Grimes Planning and Zoning Commission Meeting February 4, 2025 @ 5:30 PM

1. Legacy at James Street Plat 2 Preliminary Plat
2. Legacy at James Street Plat 2 Lot 1 Site Plan
3. Legacy at James Street Plat 2 Final Plat

Legacy at James Street
Plat 2 Lot 1 Site Plan

RE: Legacy at James Street Plat 2, Lot 1 Site Plan

Utility Plan C400-C404

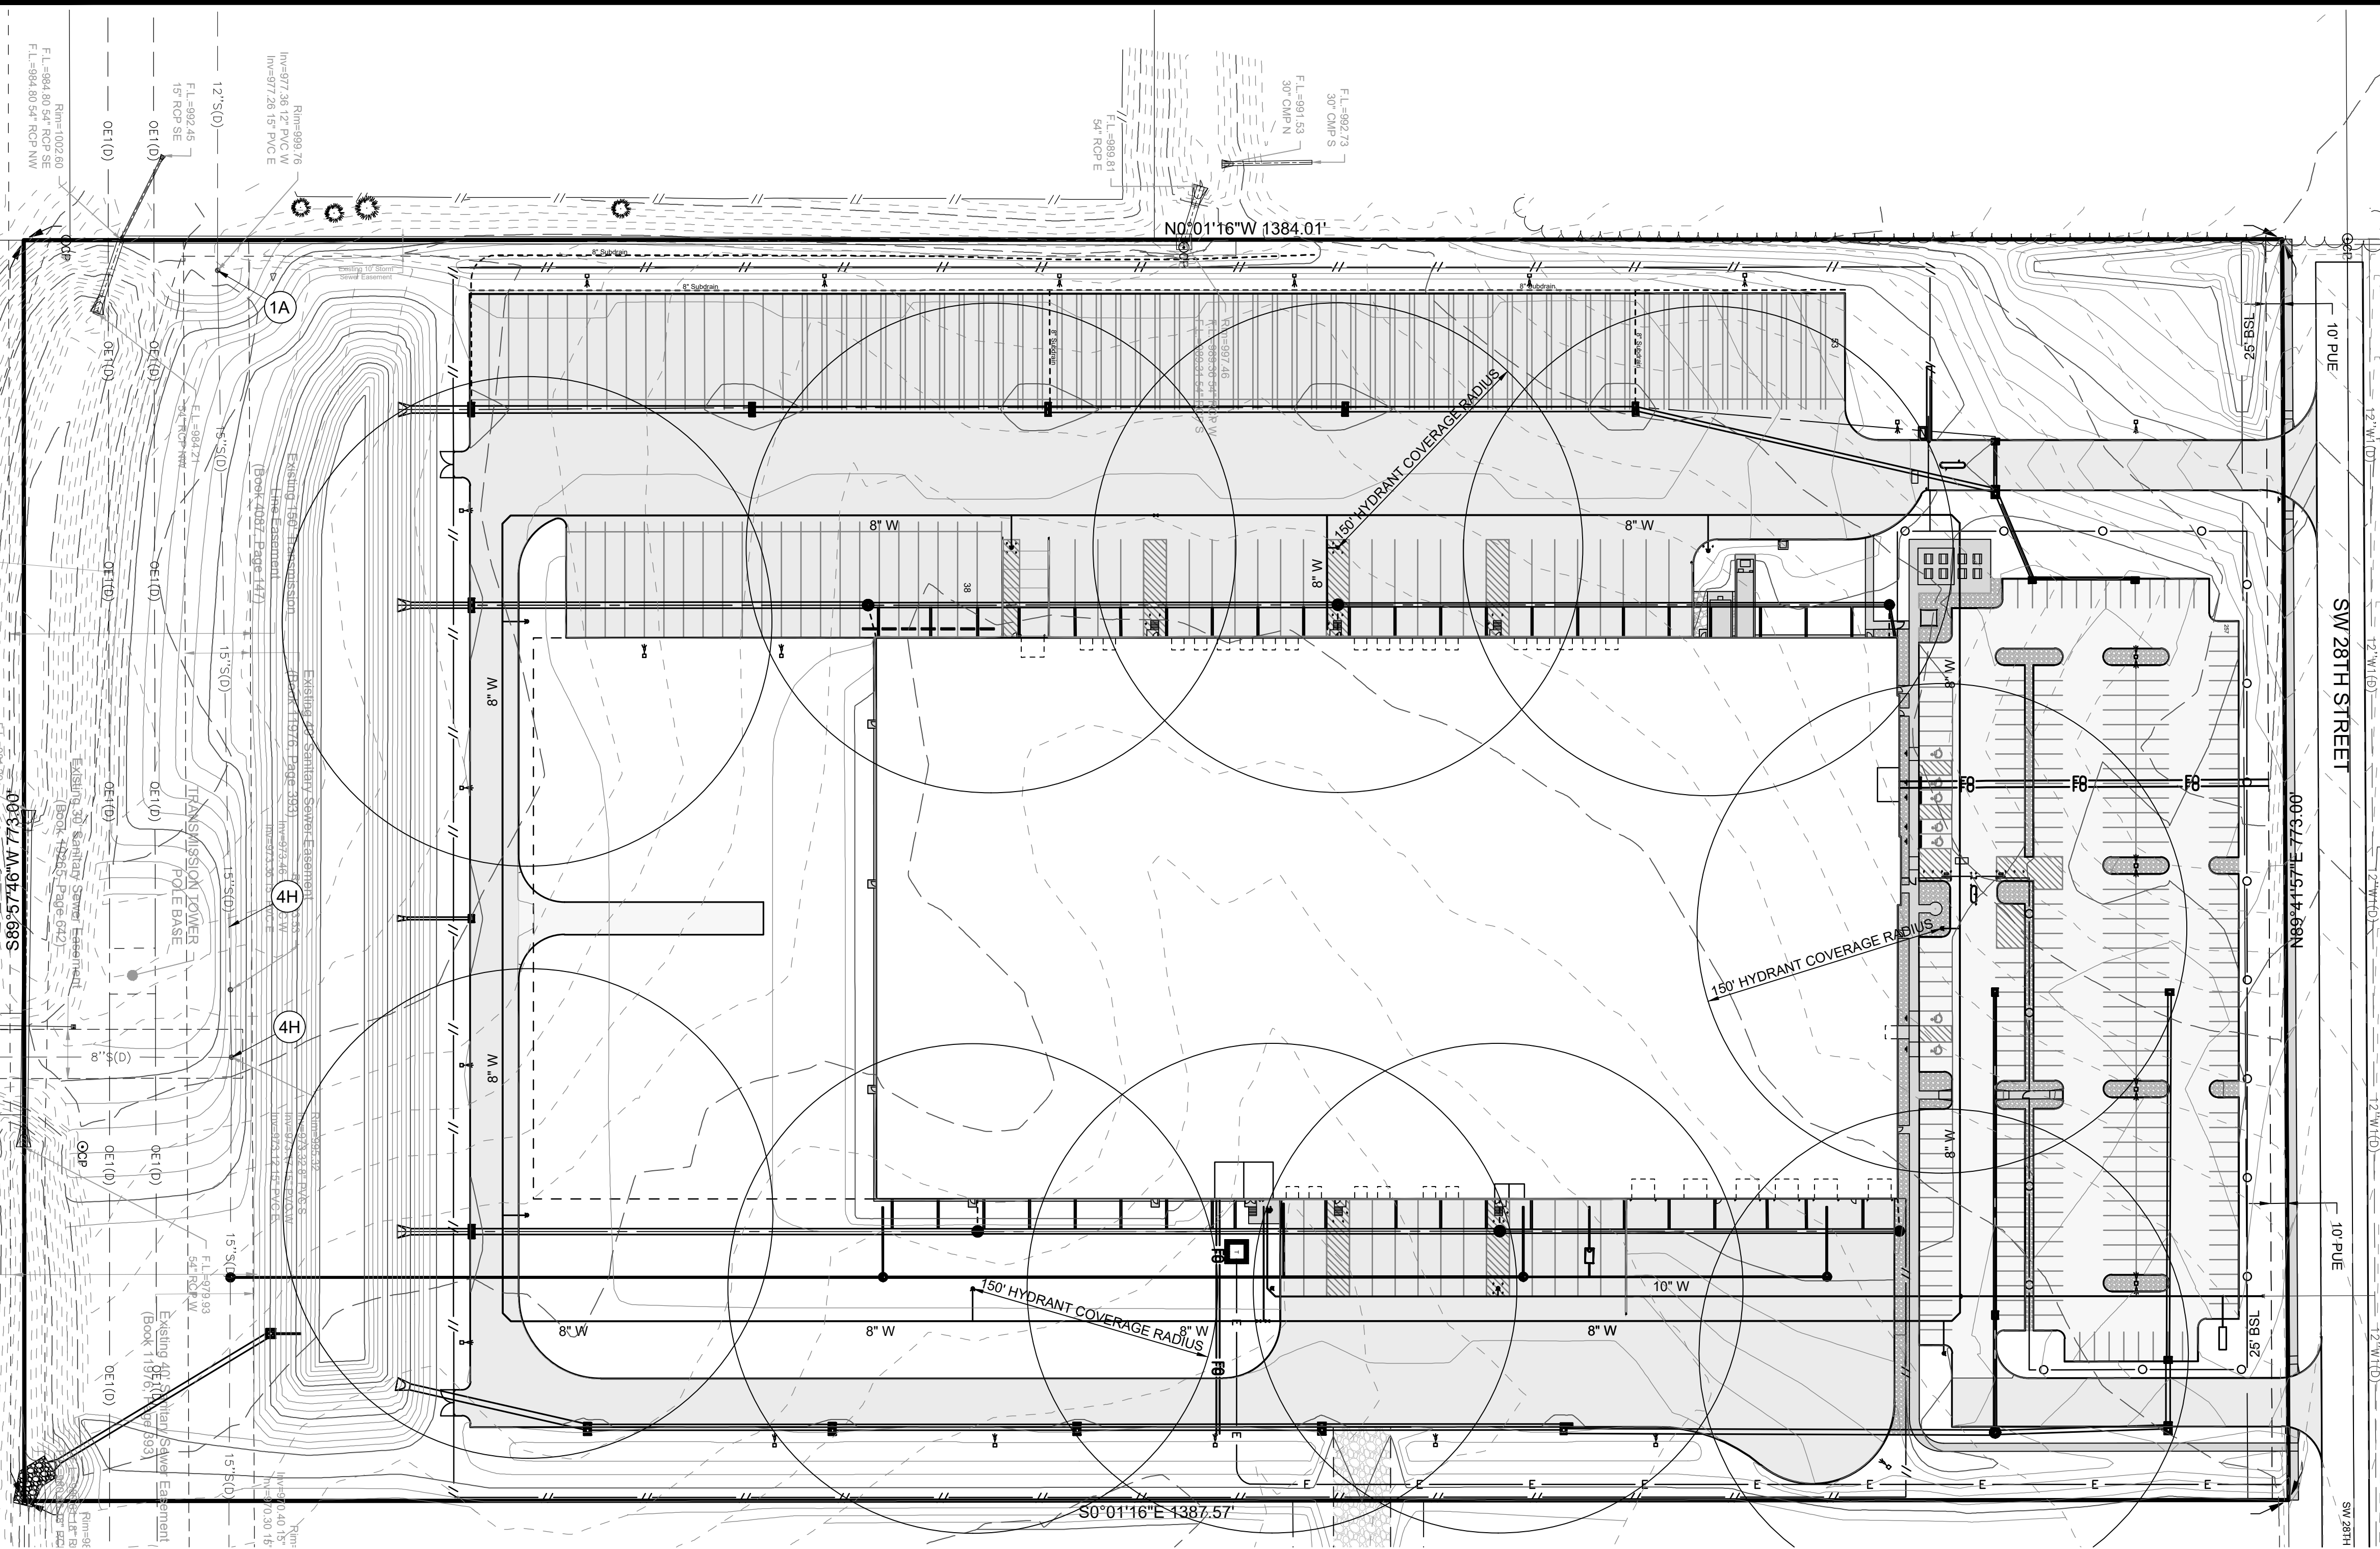
3. ~~Mark 8" sanitary line as private if it only serves the proposed building.~~
4. Please clarify the water line sizes. Construction drawings shown 8" and the site plan shows 12" and 10" water lines. Staff understands that 12" is needed. **Please coordinate with CDA (Erin Ollendike - Project Manager) on water service line sizing, connection fitting, and location of stub to coordinate with the SW 28th Street project.**

11. Sheet C400, Note 3.F. calls out for a remote FDC. Please provide the location of the remote FDC.
12. Please provide the size of the water oil separator.

13. How many tons of rip rap at the flared end outlets into the pond?
14. Provide label for the water crossing of the 8" and 10" water lines. If this is not a crossing, please explain what is occurring at the location highlighted below in red.

15. Where are the 8" and 10" water line services connected to each other? Is it the location highlight above in red? If this is not the connection point, how will the 8" water line receive water from the 12" water main along SW 28th St?
16. It appears there is an 8" water service and 10" fire service line running into the building. Please show the domestic and fire services similar to the image below.

17. Please verify the domestic and fire service sizes with the MEP. These services seem a bit large. The City does not have an 8" or 10" water meter sizes on hand so these would need to be ordered and paid for by the developer. Typically, the water meters for this type of facility are 2 or 3 inch.

19. Revise the sanitary sewer service size to 6".
20. Revise 4H. The molded plastic interior infiltration barrier shall be heat shrink wrap instead. (Grimes Supplemental Specifications, City Design Standards, 4 Sewers and Drains, g) all sanitary sewer manhole castings and adjusting rings shall be seals with heat shrink sleeves.)

21. Verify that the 4" shutoff will need to be a valve and not a curb stop.
22. On sheet C404, ST-29A invert is lower than downstream invert. Is that correct, or should it be adjusted?

Planting Plan C500-C504

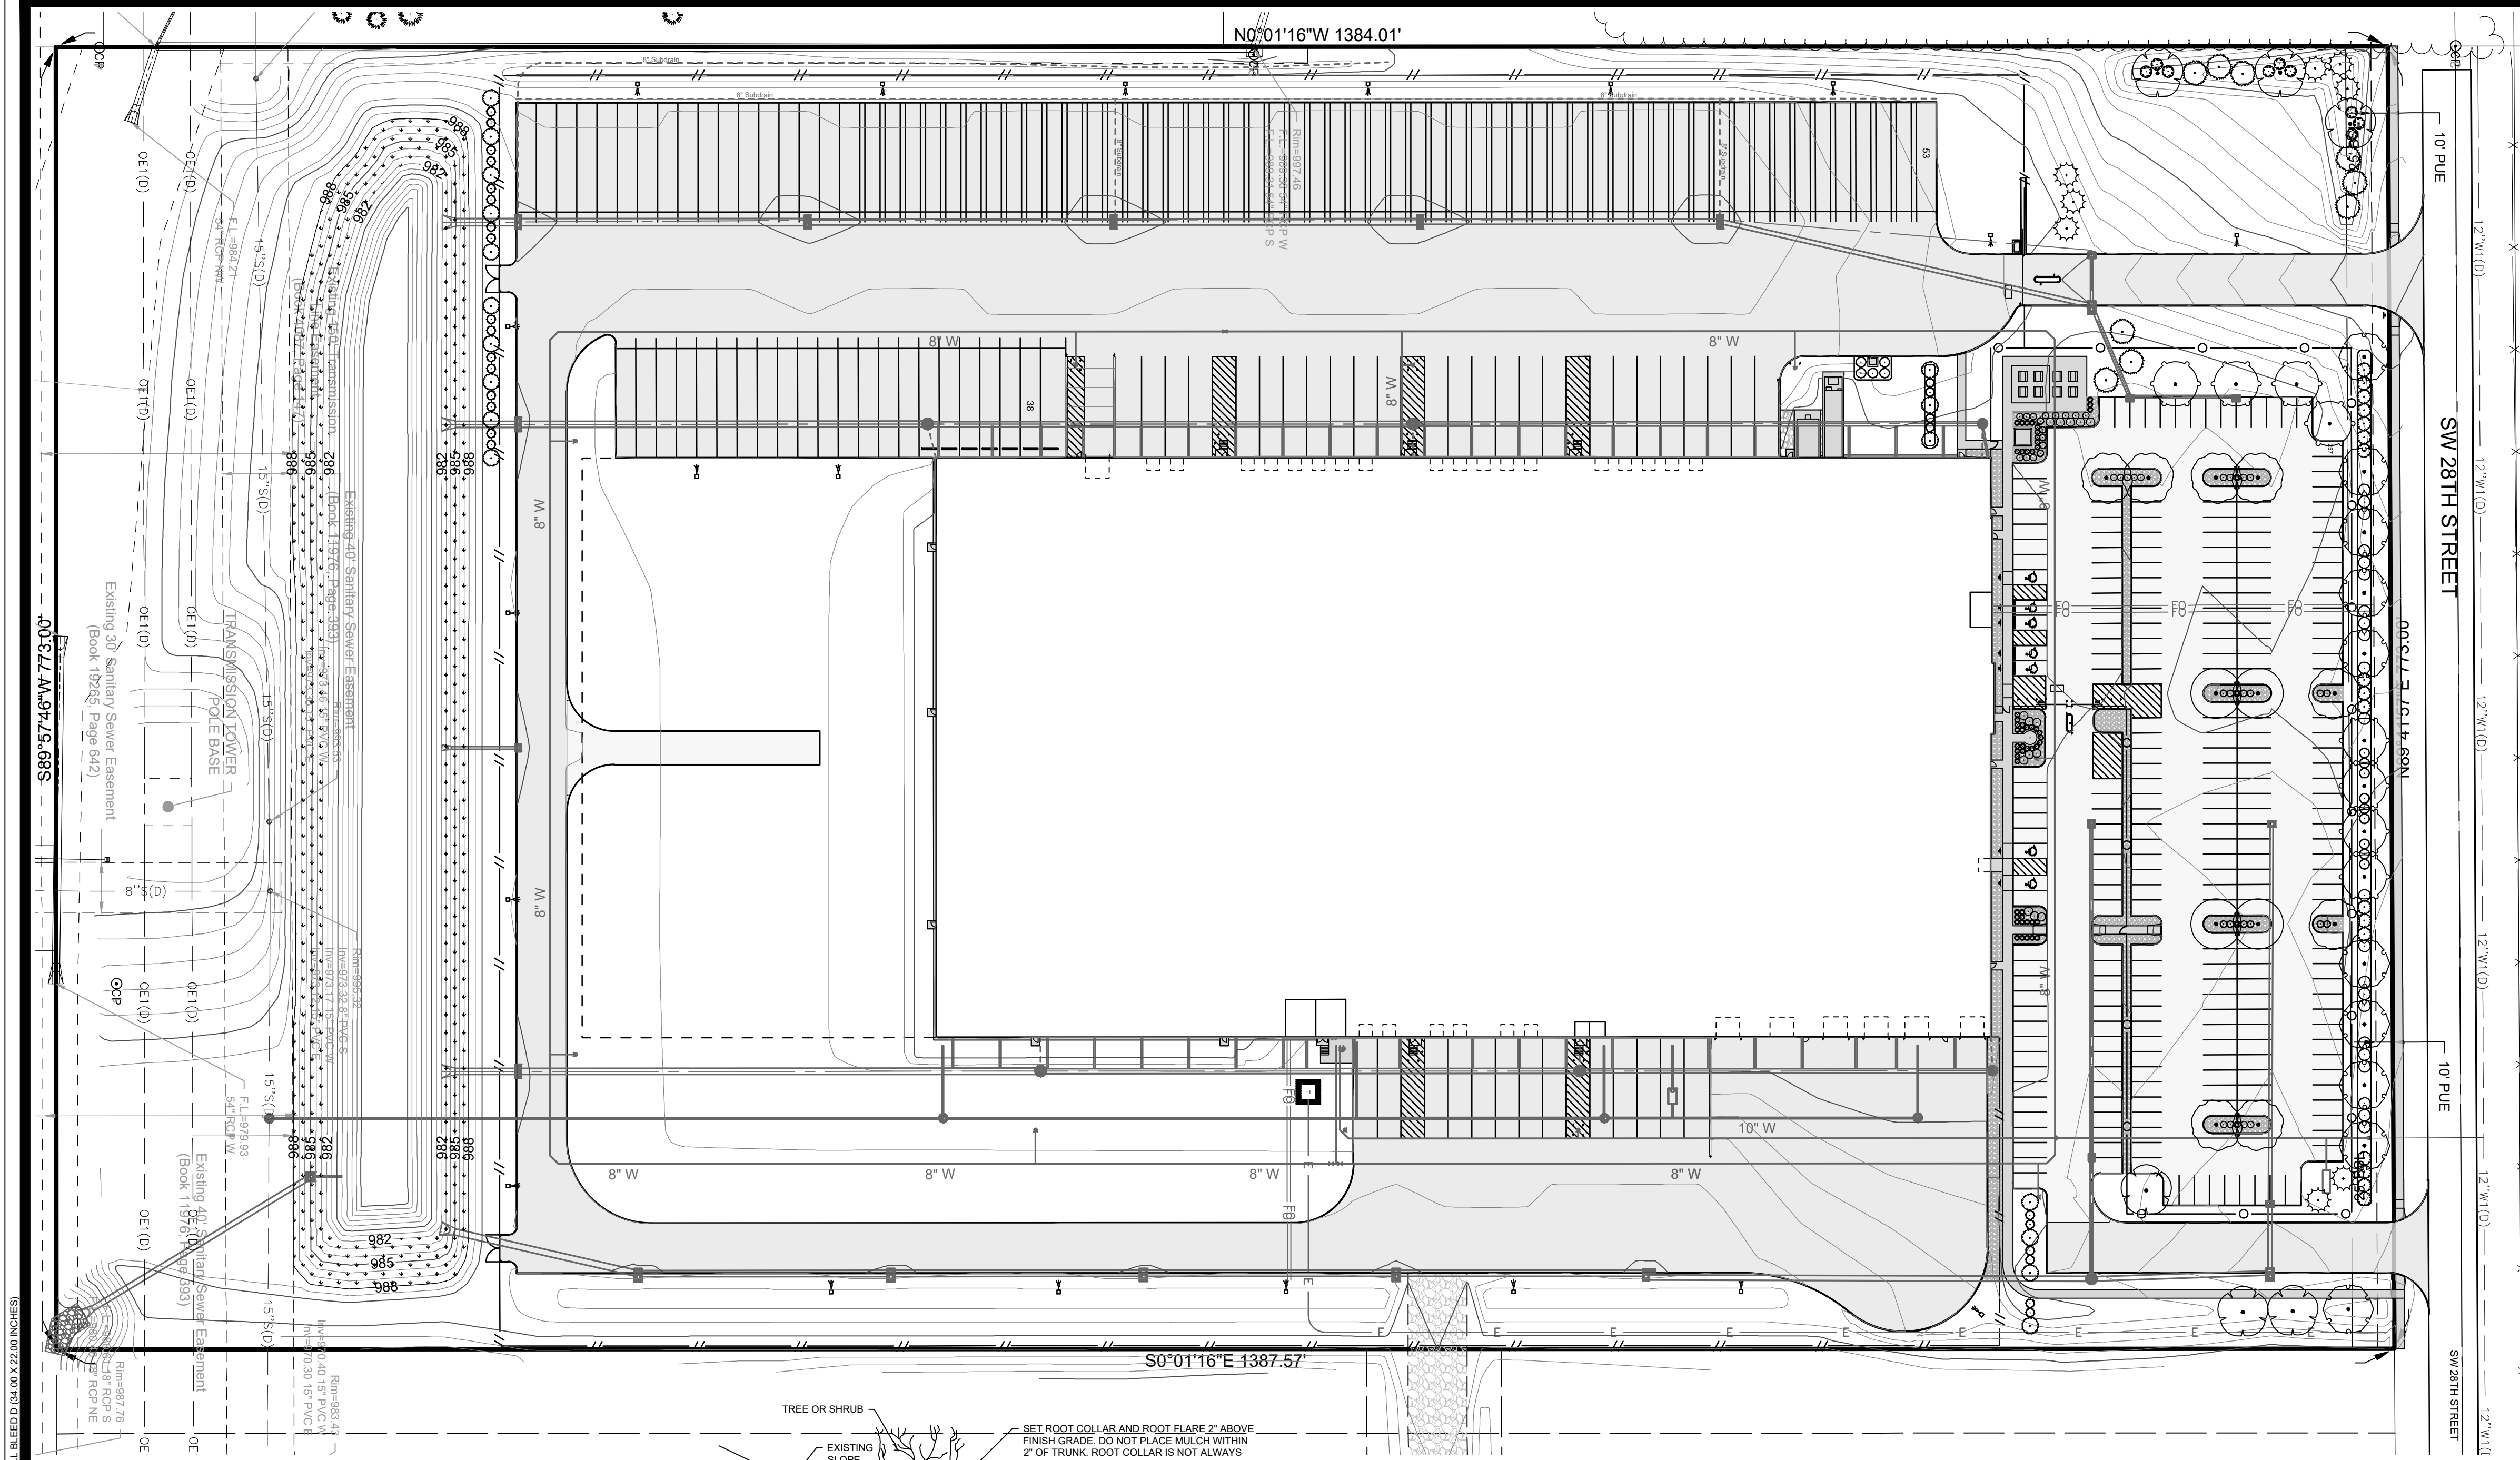
1. Please add landscaping plantings to provide additional screening along the West property line where no landscaping buffer is present to effectively screen the outdoor storage area. [Section 12-5-15](#)
 - a. As discussed in the meeting on 12/30/24, an opaque fence is the preferred option that will screen most of the height of the outdoor trailer storage area as shown by the green line in the map below.

- b. After further review of the development agreement, staff would accept an alternate screening plan for the outdoor storage area to screen the outdoor storage area from public view i.e SW 28th St and S James St. The screening would be provided by landscaping in accordance to the outdoor storage buffer requirements outlined in the development agreement.

- i. Shift the north frontage berm south to provide immediate screening for the area from SW 28th St

- ii. Add loading buffer plantings north of the DEF tank

- iii. Provide landscape buffer along the south end of the outdoor storage area. Buffer plantings are required to follow the outdoor storage buffer requirements as outlined in the development agreement.

2. Foundation plantings are required per the transportation overlay requirements. Plantings include deciduous and coniferous shrubs, and perennials. The image attached shows possible locations for more foundational plantings.

3. Per the development agreement, there will need to be a 30' loading area buffer to screen the loading area from 28th street. The agreement calls for 2 understory and 3 evergreen trees per 50 lineal feet. Please add this buffer shown in the location on the image below. The sidewalk could be kept in the same location with plantings located on either side of the sidewalk. In this case, the sidewalk width would not count towards the 30' buffer width. Alternatively, the sidewalk could be shifted along the drive aisle pavement with the buffer plantings located south of the sidewalk. Ensure that plantings do not conflict with the utilities in the area. **Will the evergreens take more bush height or a tree height for this loading buffer?**

4. Please ensure there is separation between light poles and plantings. There appears to be shrubs on top of the light pole locations.
5. Plantings cannot be on top of stormwater infrastructure. Staff suggest locating trees at a minimum of 5 feet away from utility lines and pipes to ensure there are no conflicts with infrastructure and plantings.
6. Please provide labels for these plantings. They were correctly accounted for within the plant schedule, but are missing the labels.
